FINDLAY CITY PLANNING COMMISSION

STAFF REPORT November 14, 2019

Thursday, November 14, 2019 – 9:00 a.m.

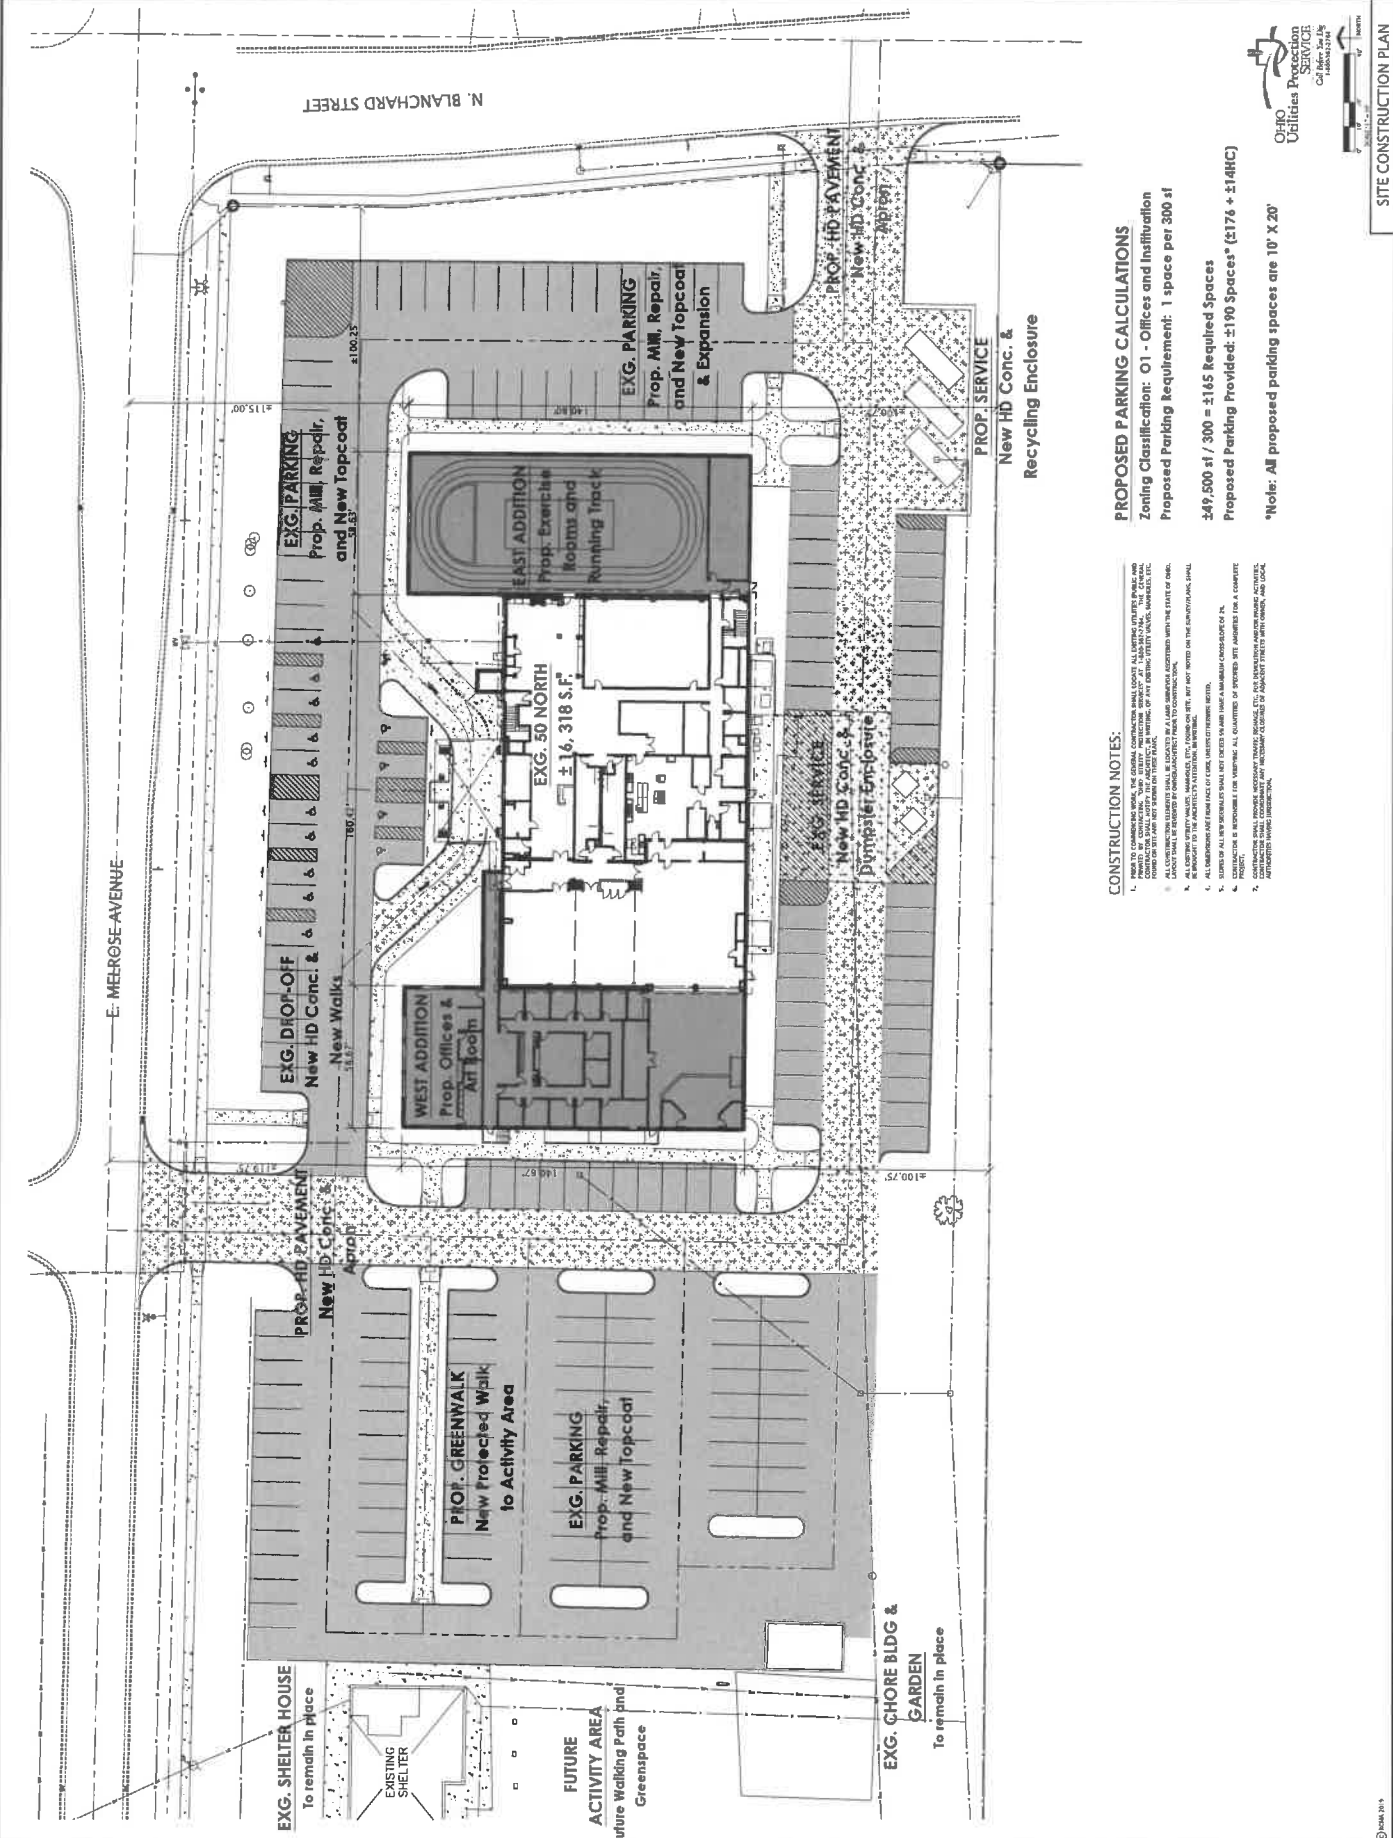
The applicant is proposing to construct new additions on the east and west sides of the building. The west addition will have a new art studio, offices and expanded dining facility. The east addition will expand the fitness center facilities and include a new indoor track.

All setbacks are well within the minimum requirements. There is no new free standing signage indicated.

The applicant is proposing to widen the existing curb cuts to allow for one lane of ingress and two for egress. This will allow for a left turn out lane.

The elevation drawings show a matching brick veneer on the new additions. The highest roof ridge of the building appears to be at 27'. The site will be heavily landscaped with foundation plantings and new perimeter landscaping around the parking areas. Landscape islands will also be added in the parking lots.

The photometric plan indicates that there are some areas particularly in the southeast corner of the lot where the readings exceed the .5 maximum threshold noted in the code. The pole details show the heights at the 25' maximum limit.

Details provided for the dumpster and recycling enclosures show that the walls will be 6' in height and constructed of vinyl fencing. Both are 3-sided structures without gates. The architect for 50 North stated that the trash truck drivers do not want gates and sometimes break them off. The recycling area is meant as a service to the community and therefore needs to be accessible for the public at all times.

- **Correction of the lighting to bring into compliance with the code. Will need to provide explanation of what was done in order to correct this.**
